General Bid Bulletin No. 9
18 June 2021

**THE MALOLOS-CLARK RAILWAY PROJECT AND THE NORTH-SOUTH RAILWAY
PROJECT SOUTH LINE COMMUTER PACKAGE CP NS-01: PROCUREMENT OF
ELECTRICAL AND MECHANICAL SYSTEMS AND TRACK WORKS (IFB No: 21-040-3)**

DATE	16 MAY 2019
SCALE	AS SHOWN
SHEET No.	18 OF 40
DRG No.	MCRP-DWG-C/M-PSS-2101
DRG S.	-
MALOLOS - CLARK RAILWAY PROJECT (MCRP) NORTH SOUTH RAILWAY PROJECT-SOUTH (NSRP-SOUTH) Package CP NS-01 : Bidding Documents SUBSTATION LAYOUT (SS No. S10)	
REV 01

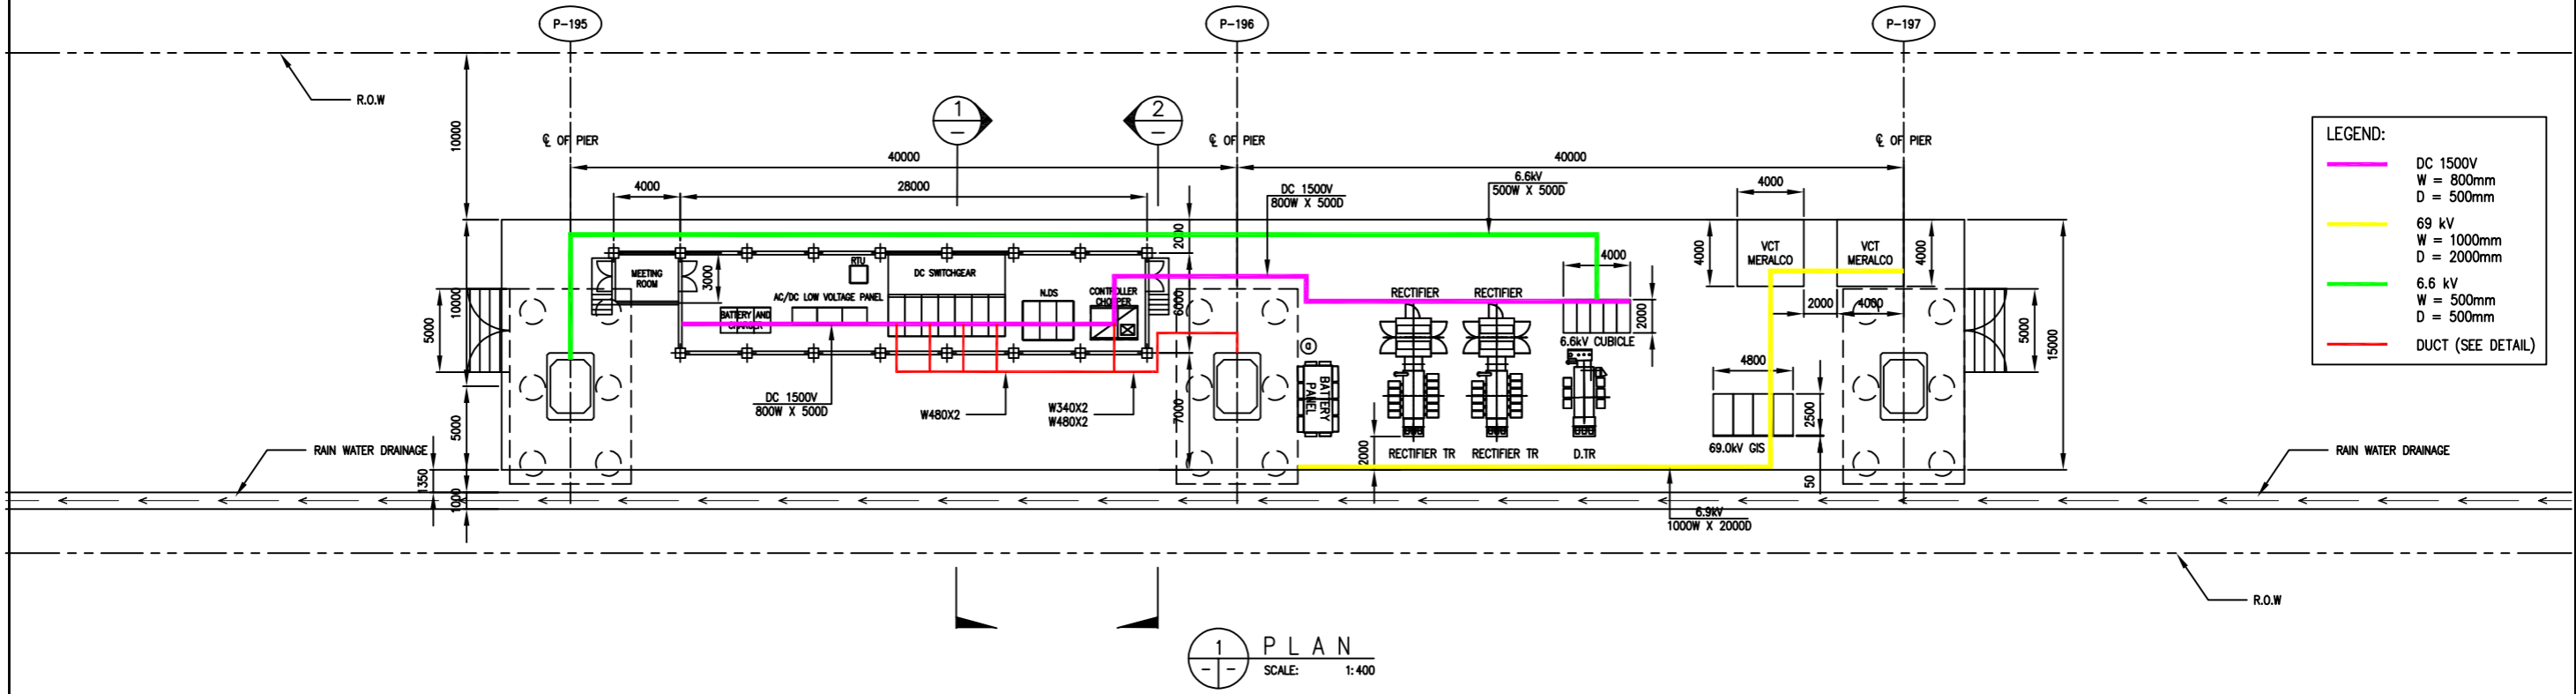
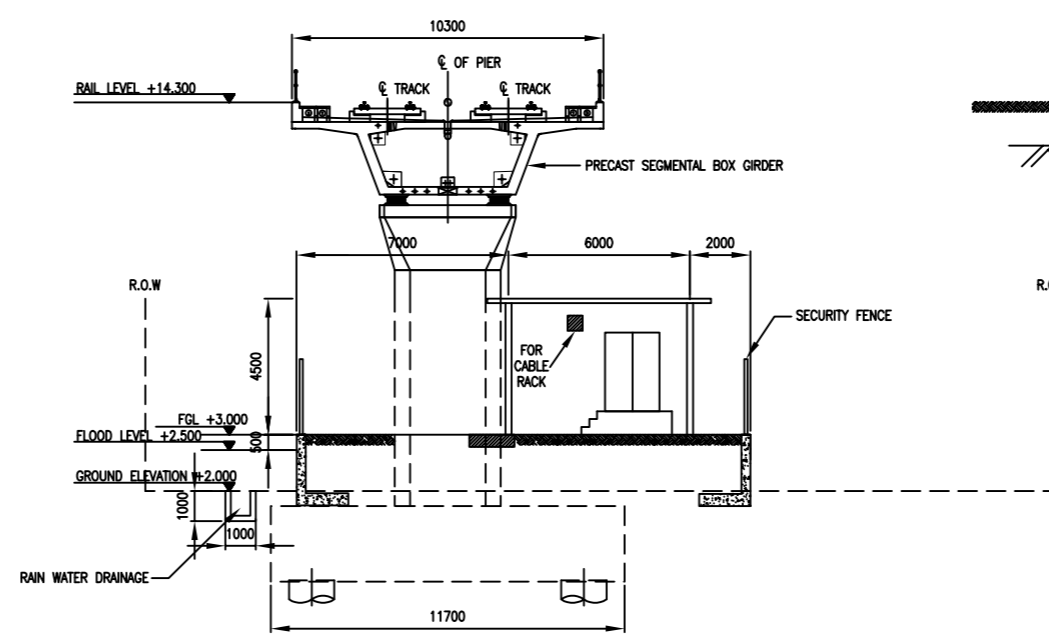
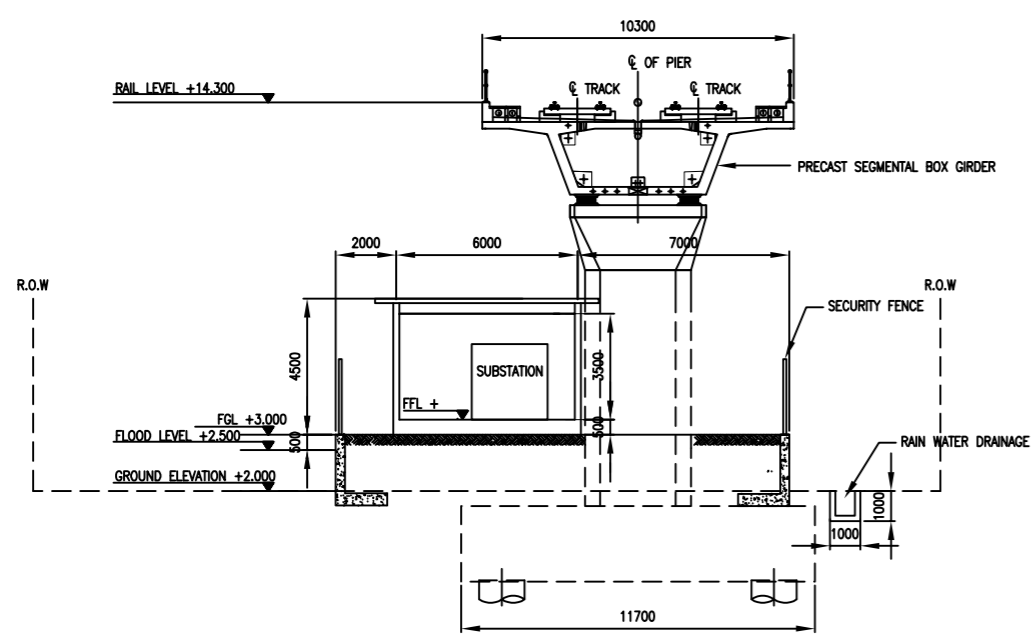
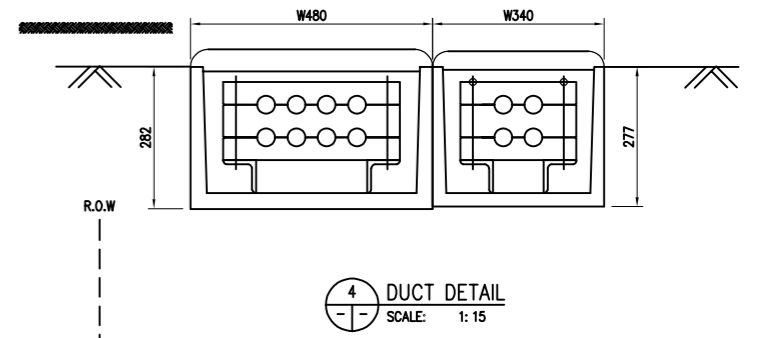
VERSIONS	DATE	DESCRIPTION
00	02 MAR 2021	ISSUED FOR REFERENCE
01	09 JUN 2021	RESISTOR CHANGED TO BATTERY POST

DATE	SCALE	SHEET No.	DRG No.	DRG S.	REV
16 MAY 2019	AS SHOWN	20 OF 40	MCRP-DWG-A/C-PSS-2103	-	01

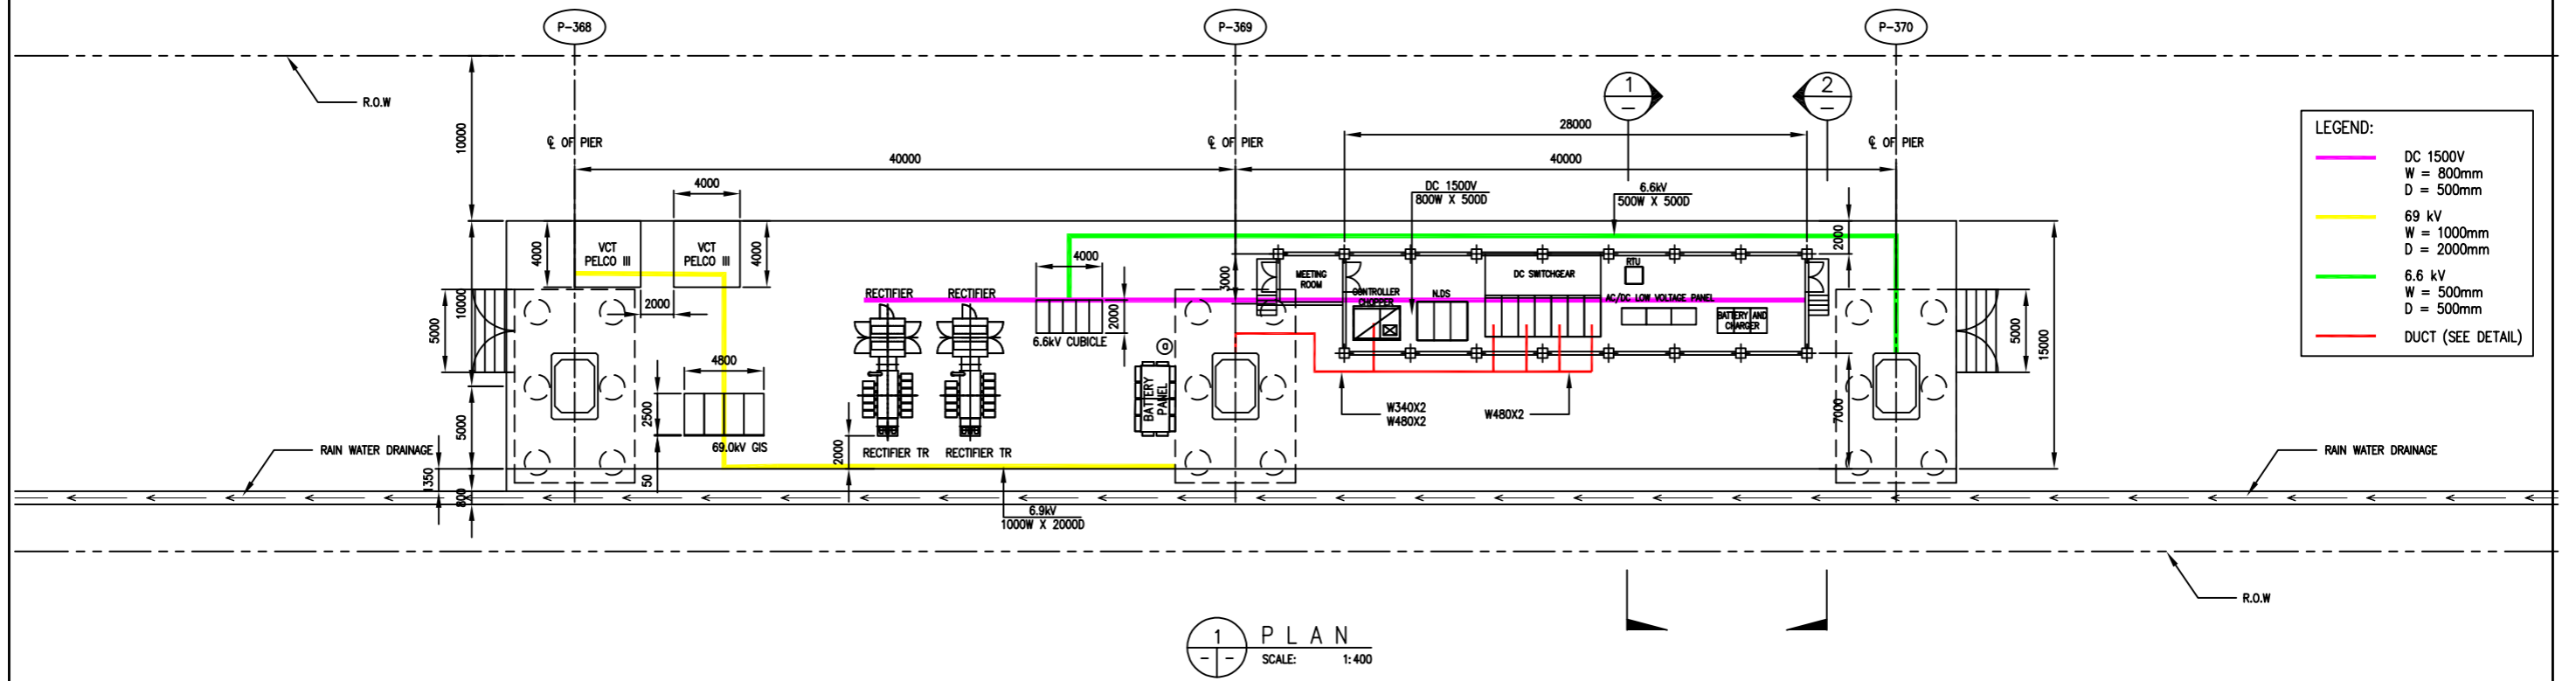
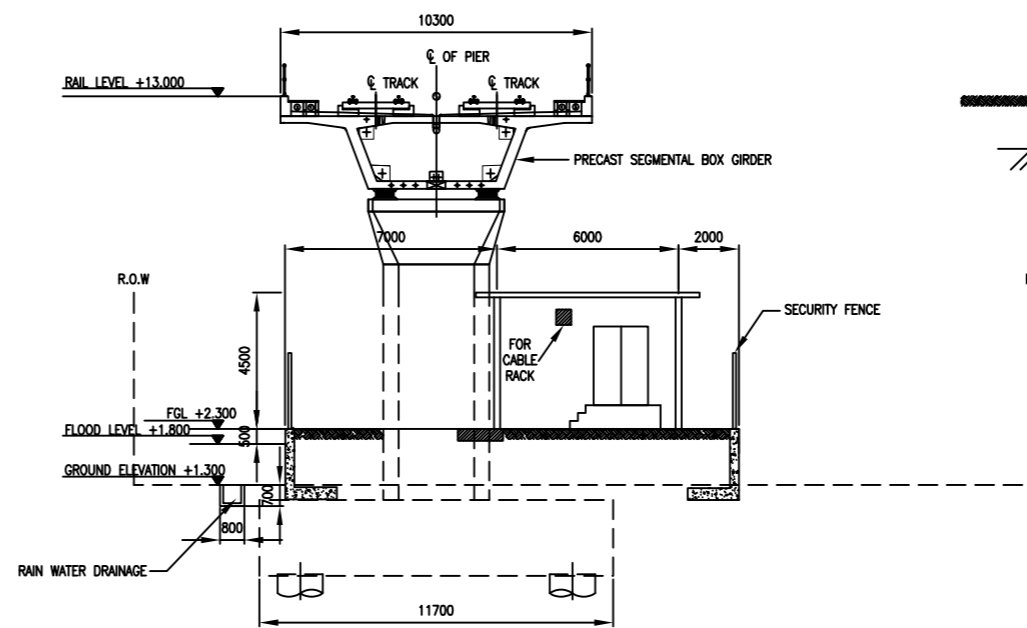
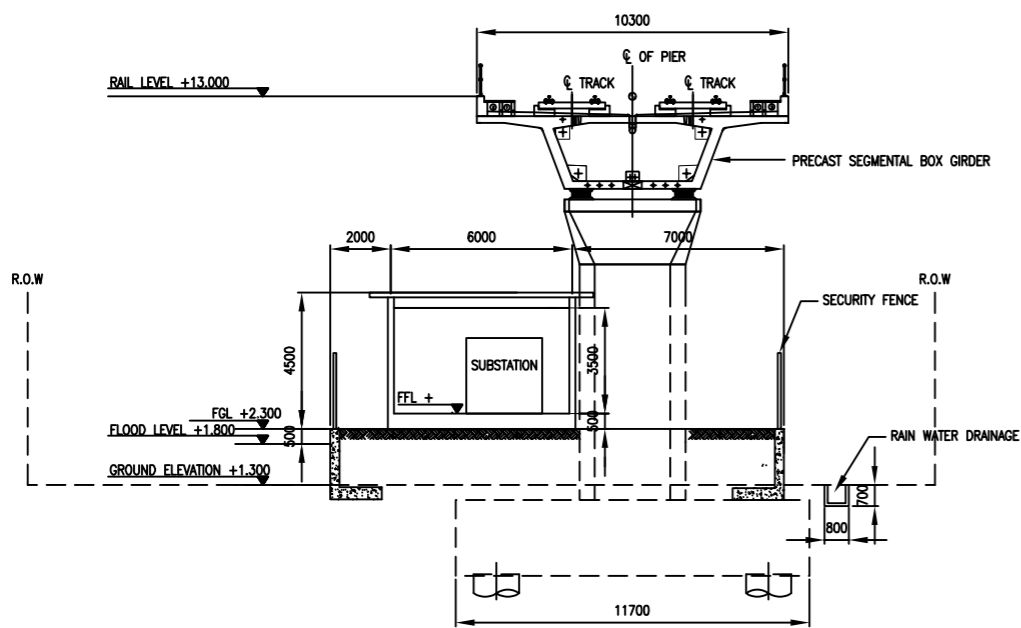
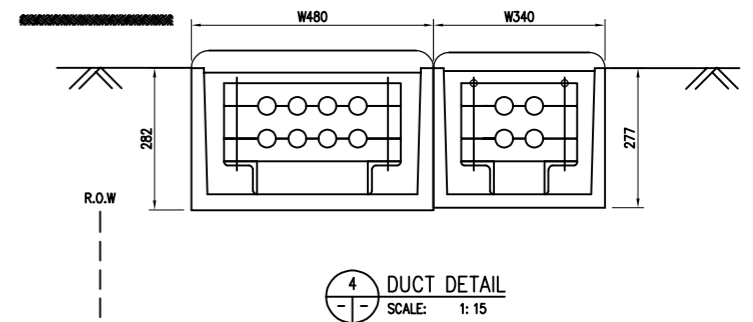
VERSIONS	DATE	DESCRIPTION
00	02 MAR 2021	ISSUED FOR REFERENCE
01	09 JUN 2021	RESISTOR CHANGED TO BATTERY POST

DATE	15 APRIL 2019
SCALE	AS SHOWN
SHEET No.	21 OF 40
DRG No.	MCRP-DWG-S/A-PSS-2104
DRG S.	-
REV	01

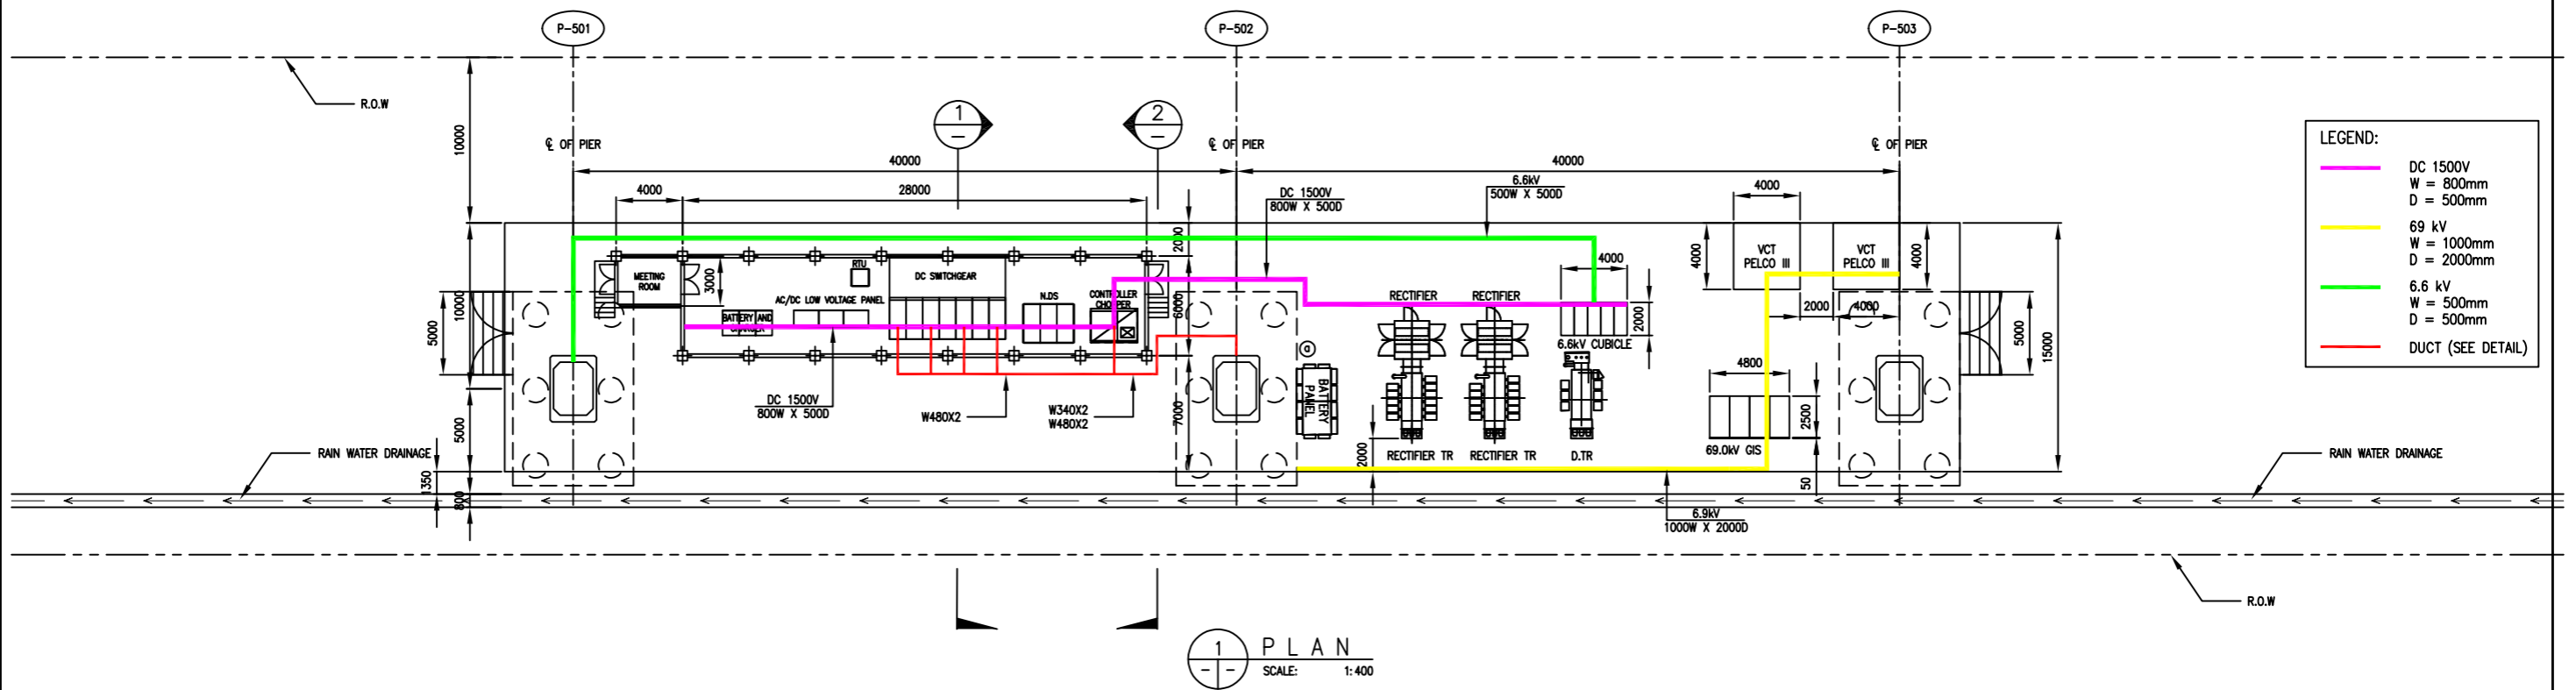
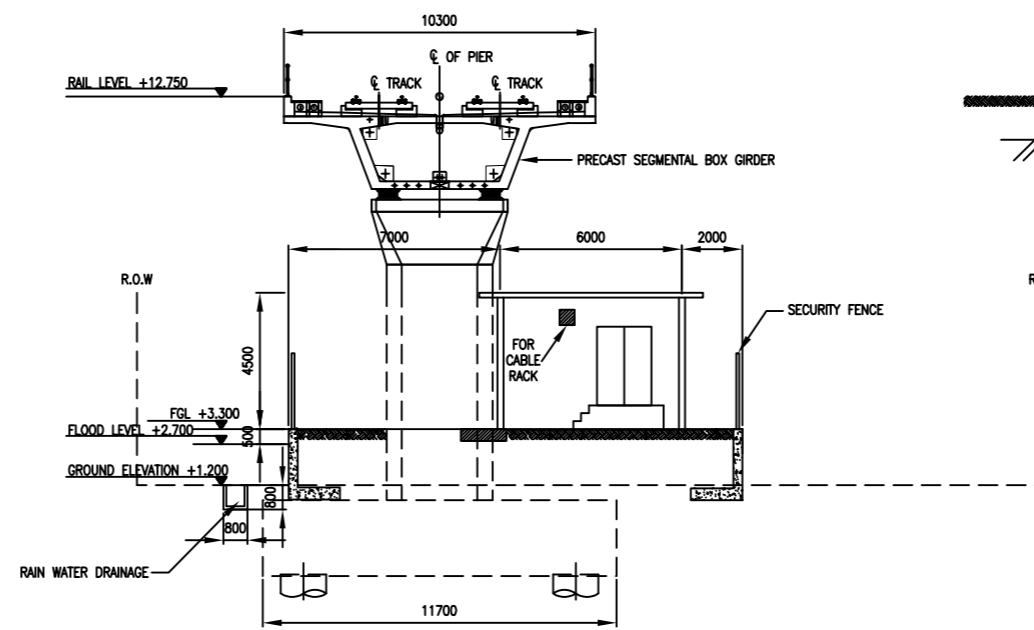
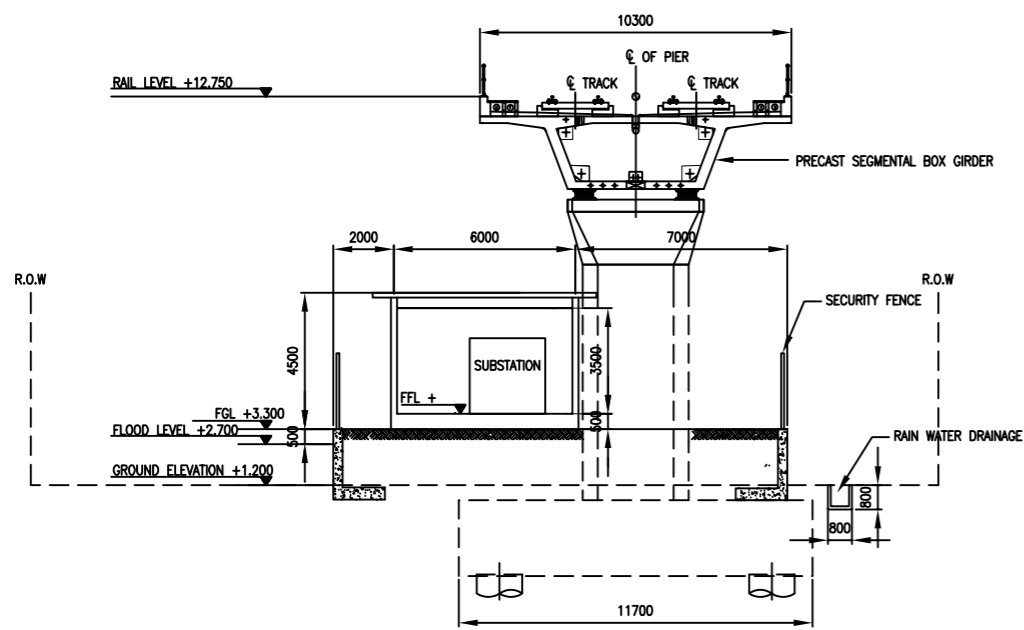
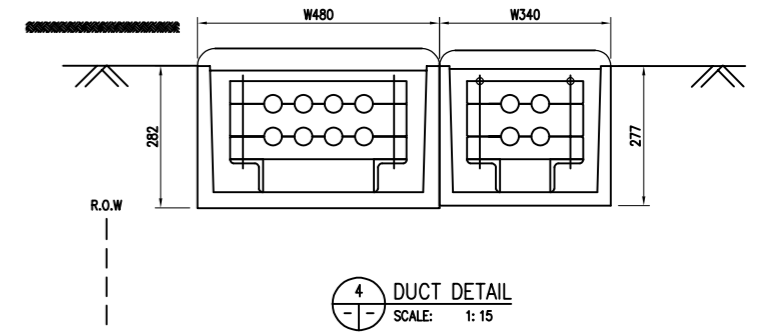
VERSIONS	DATE	DESCRIPTION
00	02 MAR 2021	ISSUED FOR REFERENCE
01	09 JUN 2021	RESISTOR CHANGED TO BATTERY POST
